E5061A-06

S E R V I C E N O T E

E5061A ENA Series Network Analyzer, 300 kHz to 1.5 GHz

When replacing A51 LCD, fasten the TORX T15 screws using a torque screwdriver (set to 1.02 N-m / 9.0 lb-in).

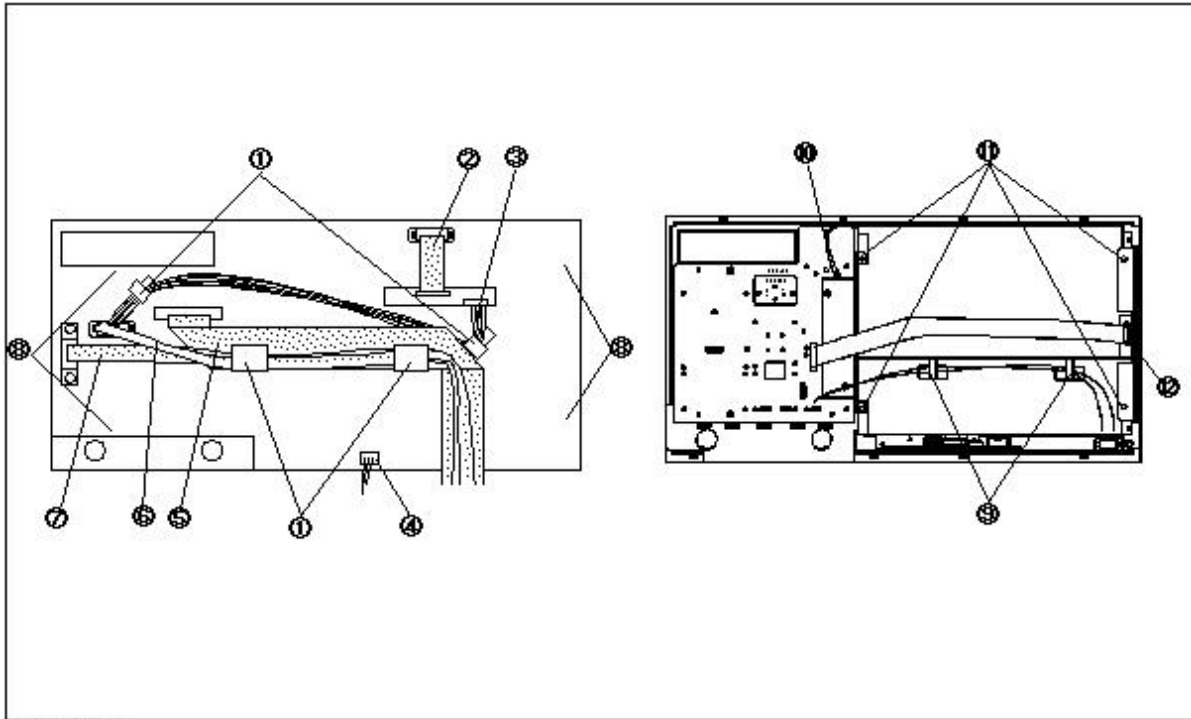
When replacing the A51 LCD, no torque info is shown in the service guide.

If you fasten the screw with over the appropriate torque, A51 LCD might be damaged, and if you fasten the screw with under the appropriate torque, LCD module might not be fixed against the vibration.

Fasten the TORX T15 screws (item 11) using a torque screwdriver (set to 1.02 N-m / 9.0 lb-in).
